ADDENDUM NO. 4 SEPTEMBER 19, 2025

PROJECT: PECOS COUNTY WCID #1

WATER TRANSMISSION & DISTRIBUTION LINE SYSTEM IMPROVEMENTS

2" CASING VENT DETAIL

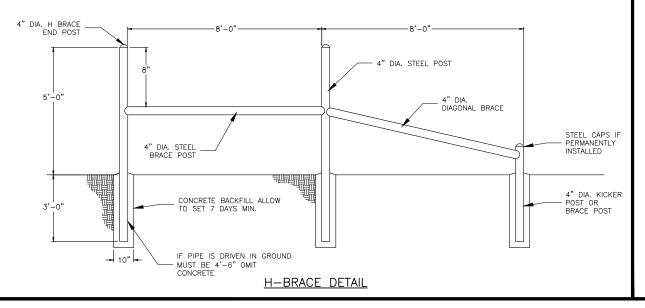
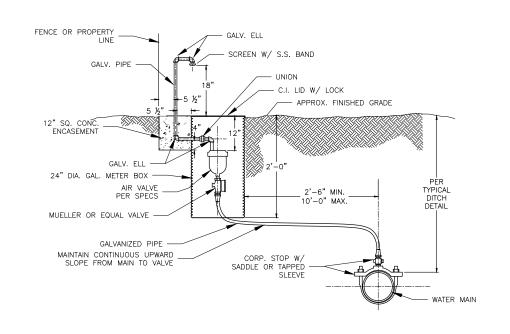
Sheet 127 is hereby revised to include a 2" Casing Vent Detail. Sheet 129 is hereby revised to include a 1" Casing Vent Detail for Long Side Service Reconnection or New Service. Revised Sheets 127 and 129 are attached.
